RE: Lot 2 Elm Grove Villa - Smith Plumbing & Heating; Water Quality Detention Pond Certification

Lot 2 Elm Grove Villa  
Water Quality Detention Pond Certification  
September 12, 2024

PROPOSED DRAINAGE MAP

WQ PLAN

**DR-2**

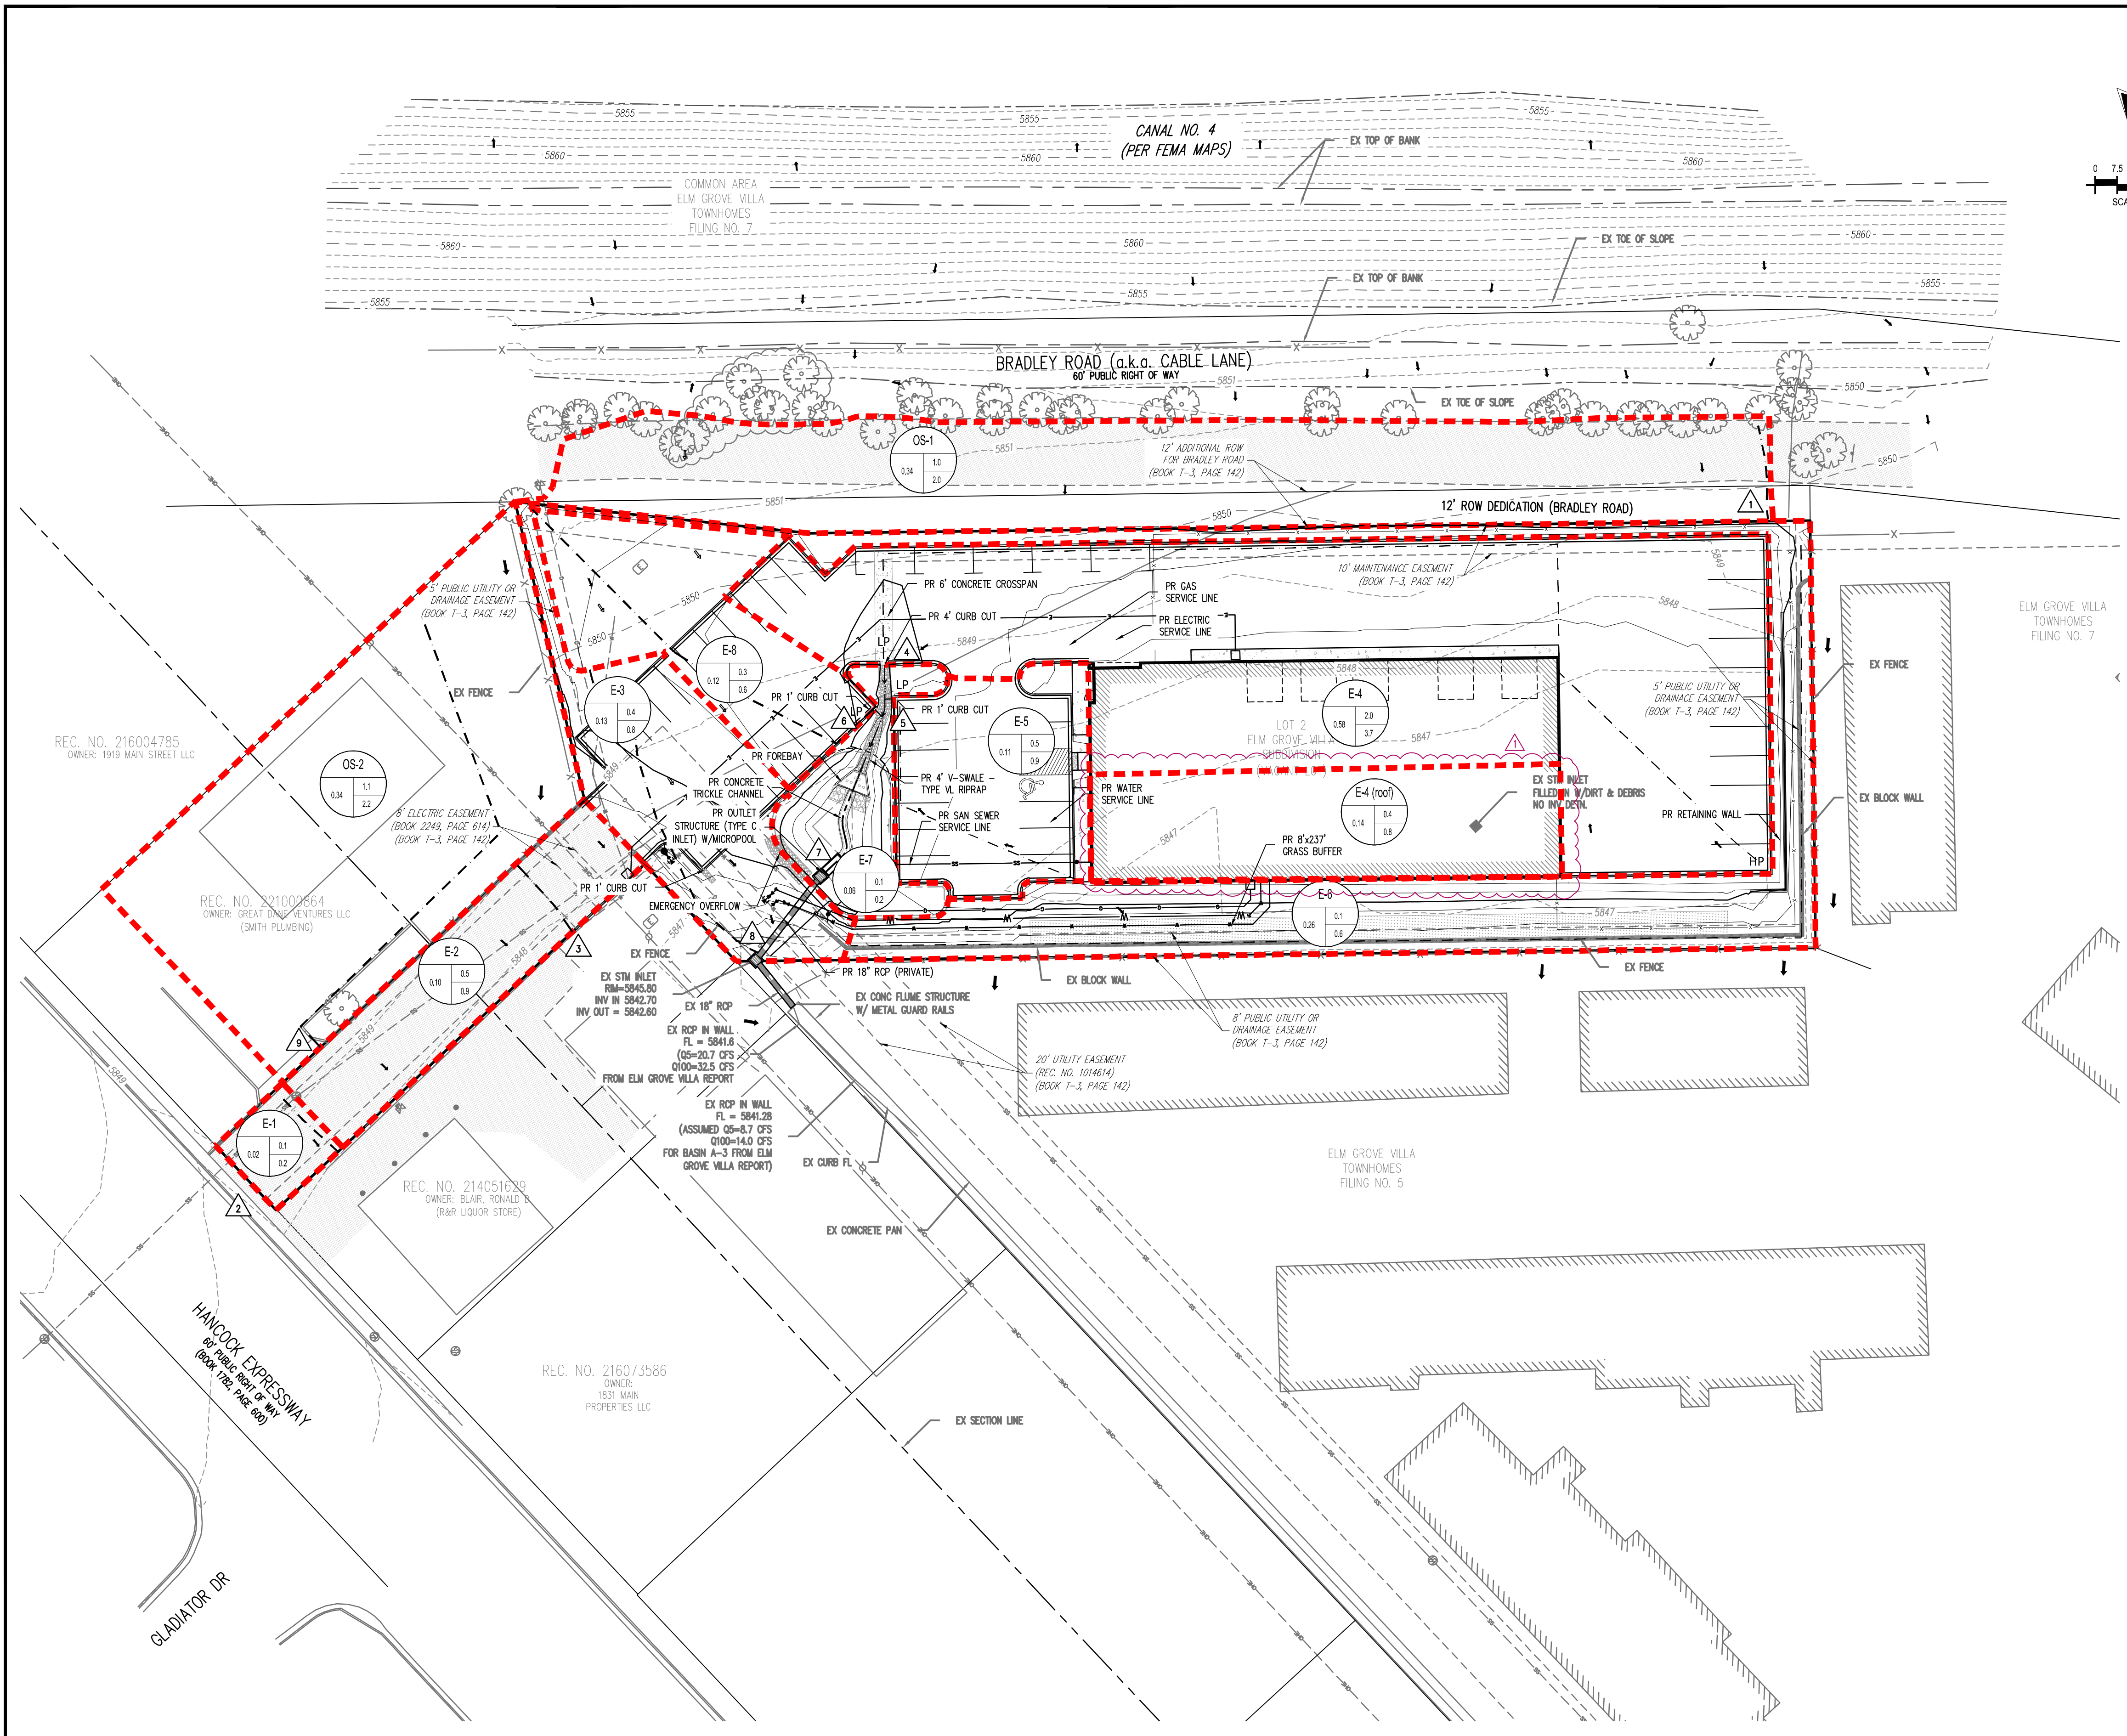
Please put a red line through this text so that it is clear that the grass buffer has been removed.

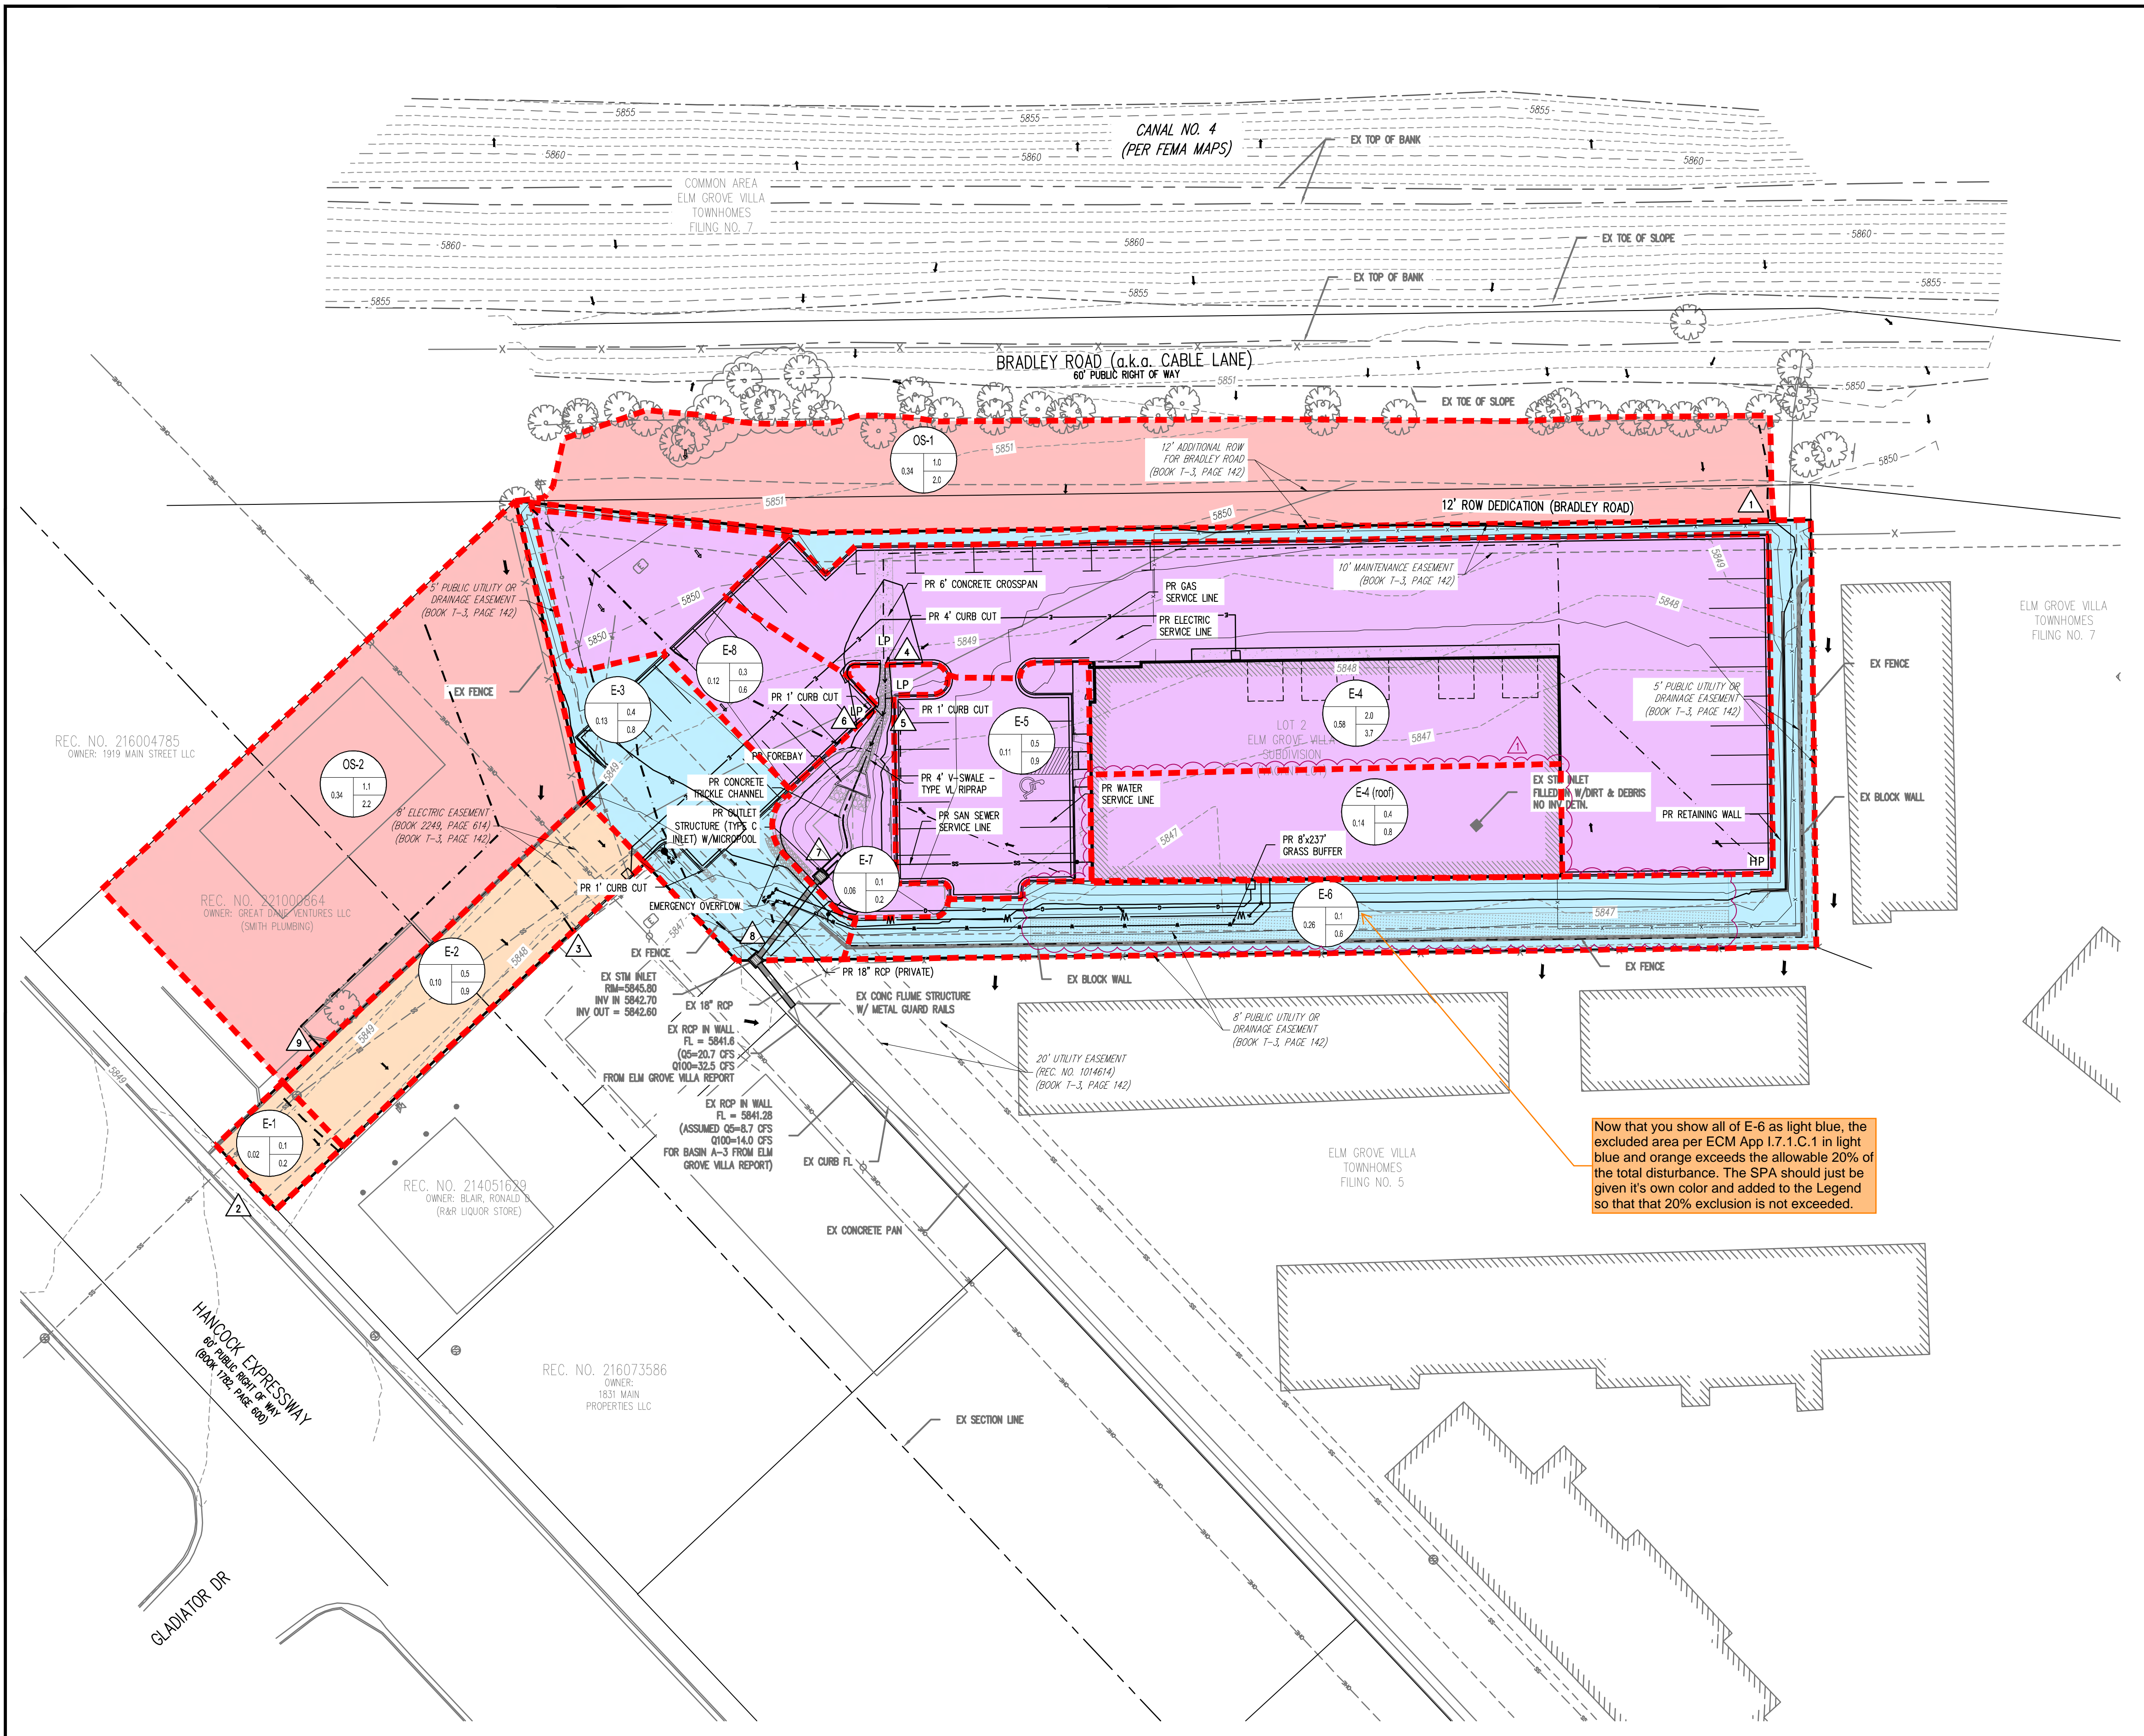
Now that you show all of E-6 as light blue, the excluded area per ECM App I.7.1.C.1 in light blue and orange exceeds the allowable 20% of the total disturbance. The SPA should just be given its own color and added to the Legend so that that 20% exclusion is not exceeded.
